<b>Subject:</b> <b>MULTIPLE ELECTRICAL MALFUNCTIONS AFTER BODY REPAIR</b>	<b>Bulletin No:</b> 09-022/14
	<b>Last Issued:</b> 05/20/2014

- 2013-2014 CX-5
- 2014 Mazda3
- 2014-2015 Mazda6

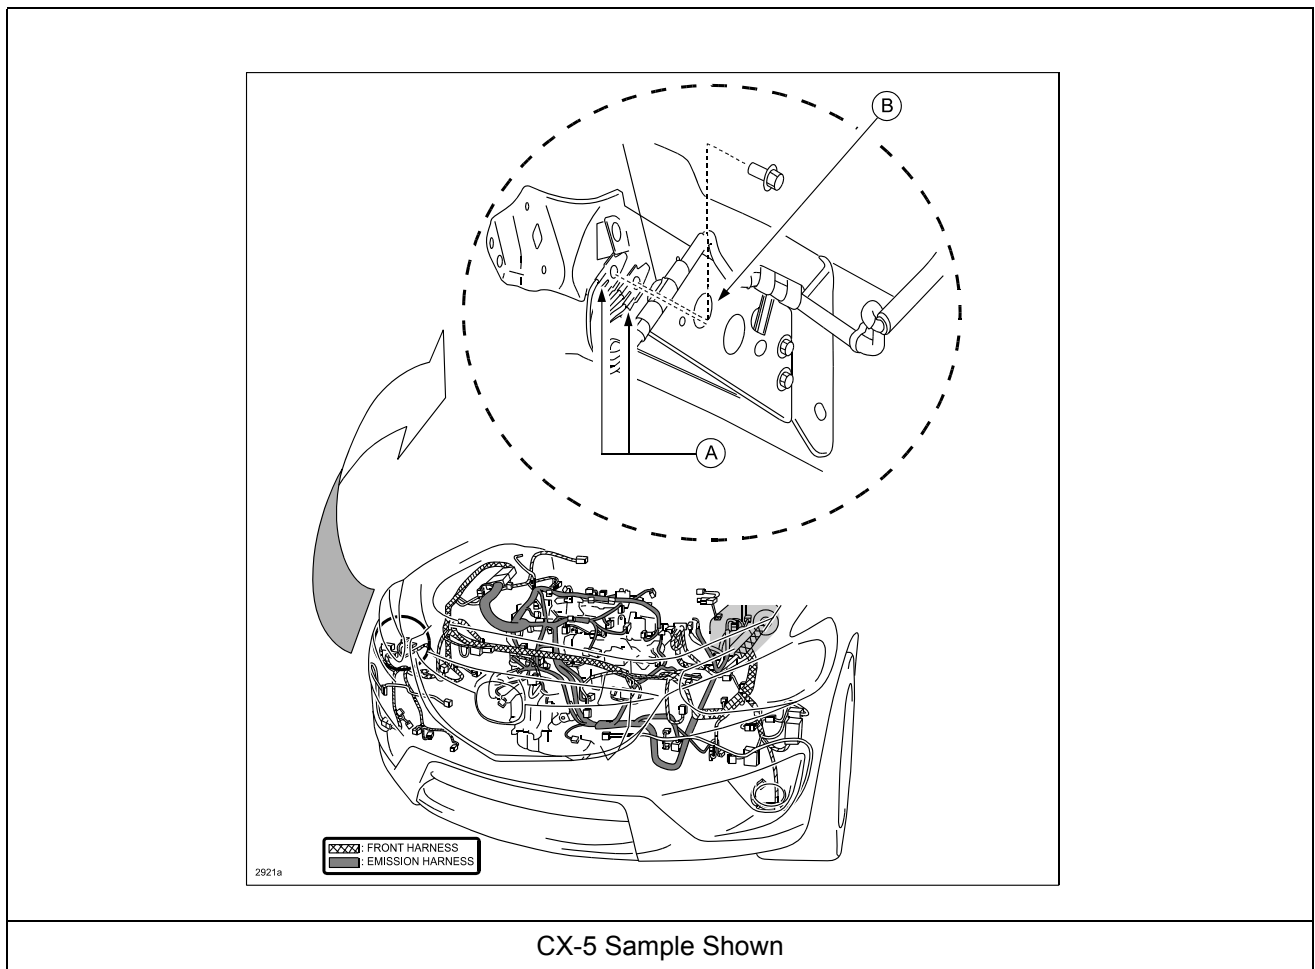
Some customers may experience an electrical malfunction after a vehicle body repair. The newly painted fender stay (B) may be causing a poor front harness (A) ground connection.

The front fender stay (B) newly painted surface at ground point (C), where attachment bolt (D) is seated, may create a poor front harness ground connection.

Customer concern can be resolved by sanding off paint at ground point (C) where attachment bolt (D) is seated. After installing the bolt (D), apply touch-up paint to the exposed base material area of the front fender stay.

## NEWLY INSTALLED FRONT FENDER STAY NOTE

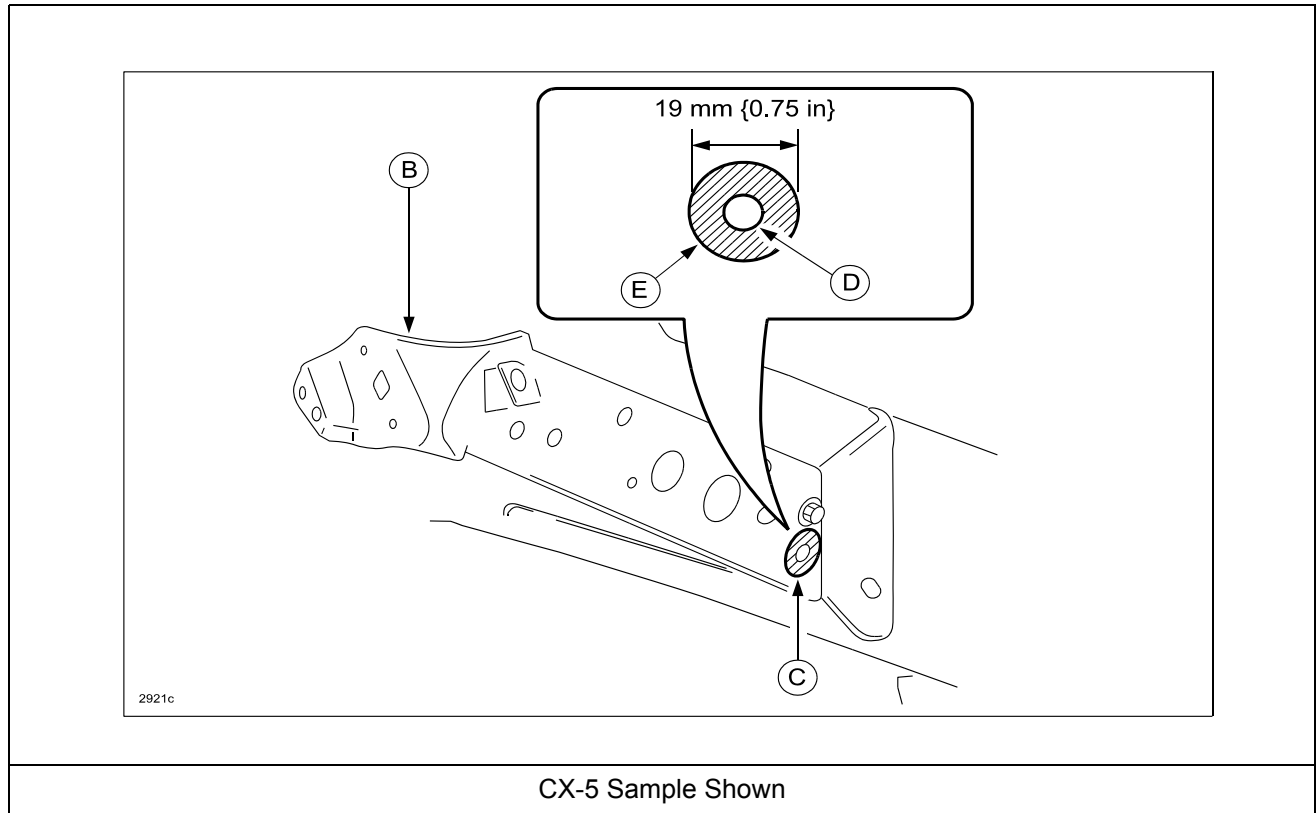
**CAUTION:** If the bolt (D) contact area (C) is painted when the front fender stay (B) is newly replaced, it could cause a malfunction in the PCM. Before painting a newly replaced part, protect the bolt (D) contact area (C) with masking tape (E) as shown in the figure.

**NOTE:** After installing the bolt (D), apply touch-up paint to the exposed base material area of the front fender stay.
